Tanker Q&As and CIs on the IACS CSR Knowledge Centre

Figure for KC ID 458

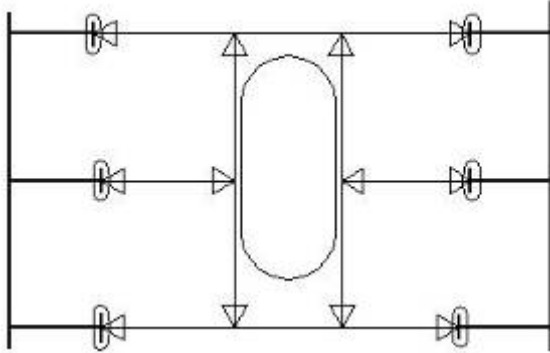
458 attc	4/2.1.1	Question	Double Skin Construction	2007/7/13	Wing ballast tank space is "Double Skin Construction", and therefore effective bending span of the stiffeners in this space is in general to be obtained in accordance with Figure 4.2.1 for "Double Skin Construction". However, if an access opening is provided (see attached figure), is it necessary for the stiffener in way of the opening to consider as "Single Skin" and obtain the effective bending span in accordance with Figure 4.2.2?	The mid stiffener as indicated in the attached sketch may be considered as "double skin construction" for the purpose of determining the effective bending span and effective shear span in accordance with Figure 4.2.1 and Figure 4.2.4, respectively, provided that the opening is only in way of one stiffener and that the opening edge, on the side of the stiffener under consideration, is stiffened with a vertical stiffener spanning between the horizontal stiffeners above and below.	<a href="#">Y</a>

Procedure for the optional shear check for primary support members with curved brackets or shallow brackets.

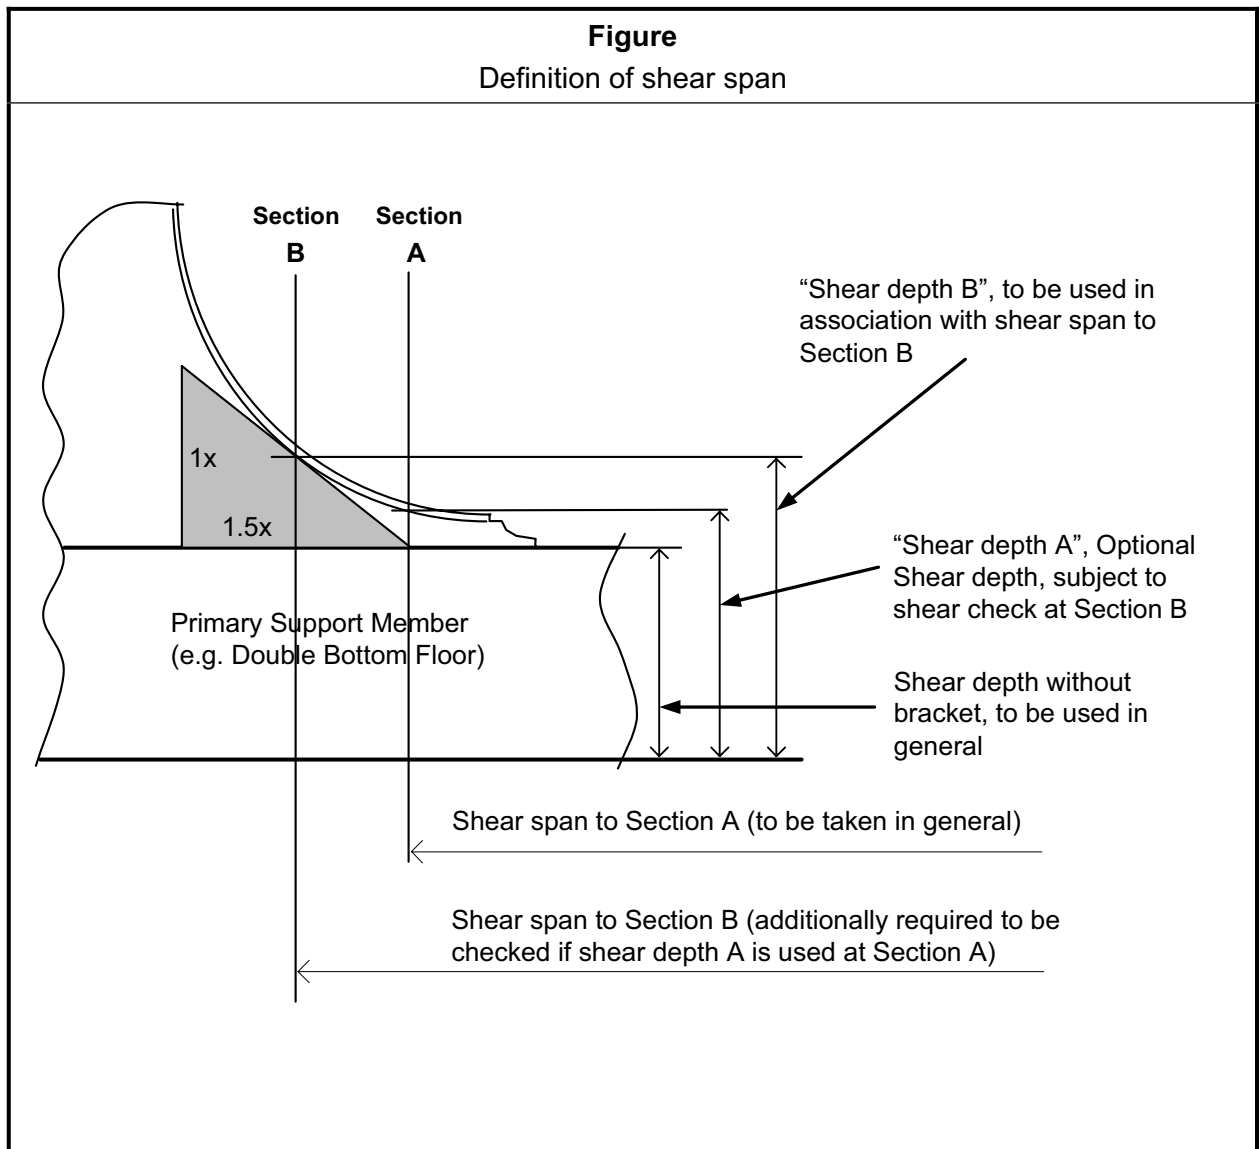
577 attc	Text 4/2	CI	Evaluation of shear strength of primary support member	2008/3/28	<p>Please clarify how to evaluate shear strength of primary support member with curved or shallow brackets</p>	<p>Please see <b>attached</b> file: 3.1 - (CIP) Common Interpretation April 2008</p>	<a href="#">Y</a>
731 attc	4/3.4.2.1	Question	Breadth of the Cut-Out	2008/5/7	<p>1. Sec4/ 3.4.2.1 states that "Cut-outs are to have rounded corners and the corner radii are to be as large as practicable, with a minimum of 20 percent of the breadth of the cut-out or 25mm ...".                      When the breadth of the actual cut-out differs from that of the standard cut-out as shown the <b>attached</b> sketch, how should the breadth of the actual cut-out be defined? (Wa, Wb or (Wa+Wb)/2)                      2. Does the requirement for corner radii apply to all of parts "a","b","c" or only to "a" and "c" in the attached sketch?</p>	<p>1. For definition of 'breadth', see attachment.                      2. The requirement apply to 'a' and 'c' only.</p>	<a href="#">Y</a>

1. In general, shear check is to be carried out at the end of shear span, Section A, with offered shear depth excluding the bracket part in accordance with 4/2.1.5 and Figure 4.2.8.

2. If the shear requirement is satisfied at this section, then no further shear check is necessary. If a curved bracket or a shallow bracket is fitted as shown in the above figure, and the offered shear requirement is NOT satisfied, then the procedure as per item 3 may be applied.

3. The shear requirement is considered to be satisfied if the shear requirement is satisfied by following two additional shear checks concurrently:
  - (a) Check the shear requirement at Section A with the shear span measured to Section A and the offered shear depth including the bracket part web "shear depth A".

- (b) Check the shear requirement at Section B with the shear span measured to Section B and the offered shear depth including the bracket part "shear depth B". At this section, the effective shear area may be calculated in accordance with 4/2.5.1.4 with the following formula considering the sloping face plate:

$$A_{w-net50} = 0.01 h_n t_{w-net50} + 1.3 A_{f-net50} \sin 2\theta \sin \theta$$

Fig.(a) Knuckled block joint

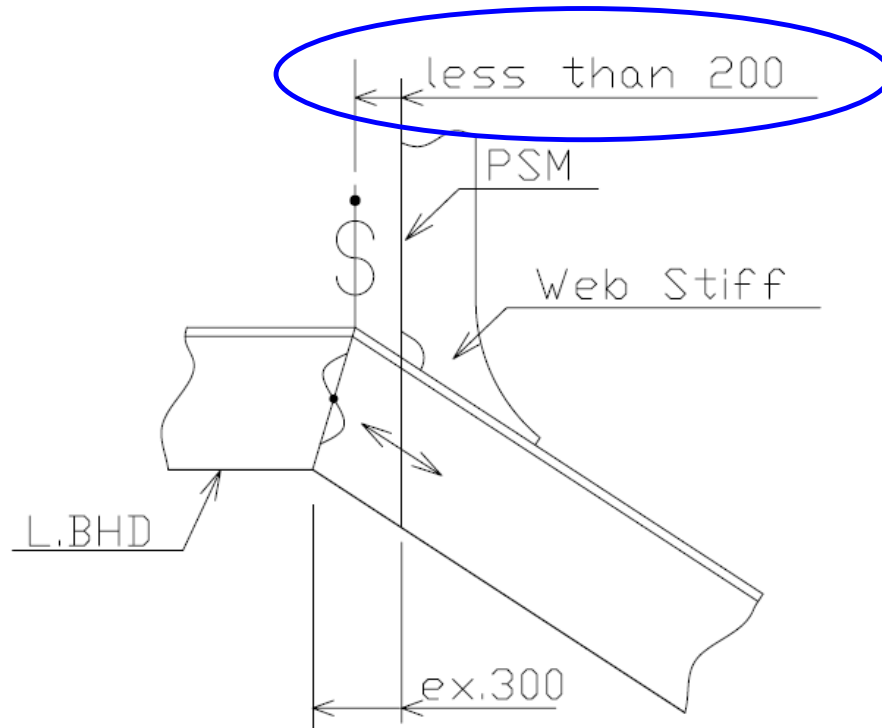
791 attc	Text 4/3.2.6.1	Question	block joint	2009/3/31	<p>(1) With regard to the knuckled block joints, block butt arrangements shown in Fig.(a) are very common. Since builders generally arrange the knuckled block joint at a nearby PSM as much as possible from the view point of strength, we think that the current requirement is impractical. Therefore, we ask that you please remove the wording "block fabrication butts" from 4/3.2.6.1.                      (2) We consider that block butt, scallop and drain hole arrangements shown in Fig.(b) have no problem because web stiffeners and tripping brackets are different from end brackets.                      (3) In the double skin constructions, are those block butt, scallop and drain hole arrangements shown in Fig.(c) acceptable? In such cases, web stiffener without bracket is provided and block butt is kept more than 200mm clear of end connection. However this block butt is kept less than 200mm clear of the bending span point.                      (4) In the double skin constructions, are those block butt, scallop and drain hole arrangements shown in Fig.(d) acceptable? In such cases, web stiffener with soft toe for fatigue design(not for span correction) is provided and block butt is kept more than 200mm clear of the bending span point. However this block butt is kept less than 200mm clear of the soft toe.</p>	<p>Please refer to the answer in KC ID <b>463</b>.</p>	<p><a href="#">Y</a></p>

Figure 15: Location and dimensions of lightening holes

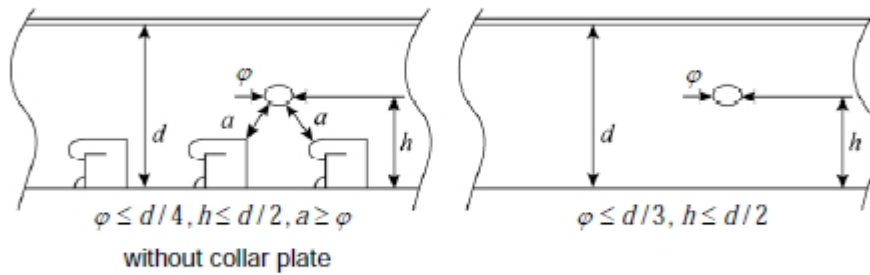
CSR-BC required the distance between opening edge and slot 'a' ≥ φ'.

Where lightening holes are cut in the brackets, the distance from the circumference of the hole to the free flange of brackets is not to be less than the diameter of the lightening hole.

While there is no such requirement for tanker.

I wonder would you like to limit the distance between opening edge and slot for CSR tankers?

1078 attc	Tanker Figure 4.2.16	Question	Definition of distance between opening edge and slot for CSR Tanker	2010/11/4	<p>Definition of distance between opening edge and slot for CSR Tanker? (Original request: Please refer to attachment)</p>	<p>The requirements concerning small openings such as lightening holes are provided in the Rules Section 4/3.5.1 to 3.5.4. We will however retain your comment for consideration during the harmonisation of the two CSR Rules.</p>	<a href="#">Y</a>
1098	4.3/3.2.3	Question	Definition of length for bracketed connection	2011/10/5	<p>The CSR-DHOT required the end bracket arm length in SECTION 4.3/3.2.3 Bracketed connections. This arm length includes the height of the attached stiffener and the height of the bracket. (<math>l_{bkt}=h_{stf}+</math>the height of the bracket) But according to SECTION 4.3/3.3.3 Brackets, the arm lengths of brackets mentioned above is obviously equal to the height of the bracket. (<math>l_{bkt}=\text{the height of the bracket}</math>) So I suggested clear clauses to be issued.</p>	<p>Paragraph 4.3/3.2.3 is concerning Local Support Members. Height of the stiffener is included in <math>l_{bkt}</math> only when the bracket and stiffener is on the same side.</p> <p>Paragraph 4.3/3.3.3 is concerning Primary Support Members.</p> <p>In 4.3/3.2.3, The term "<math>l_{bkt}</math>" is, in general, defined including the height of the stiffener (<math>l_{bkt}=h_{stf}+\text{actual height of bracket}</math>)</p> <p>In 4.3/3.3.3, the actual bracket height is required to be not less than web depth of PSM member.</p> <p>For LSMs Rules require in 3.2.3.4 that "<math>l_{bkt}</math>" is not less than 2 times the depth of stiffener web.</p> <p>For PSMs Rules require in 3.3.3.1 that actual bracket height are not less than web depth of PSM member.</p> <p>Your question will be retained and passed to harmonisation project for further consideration and clarification.</p>
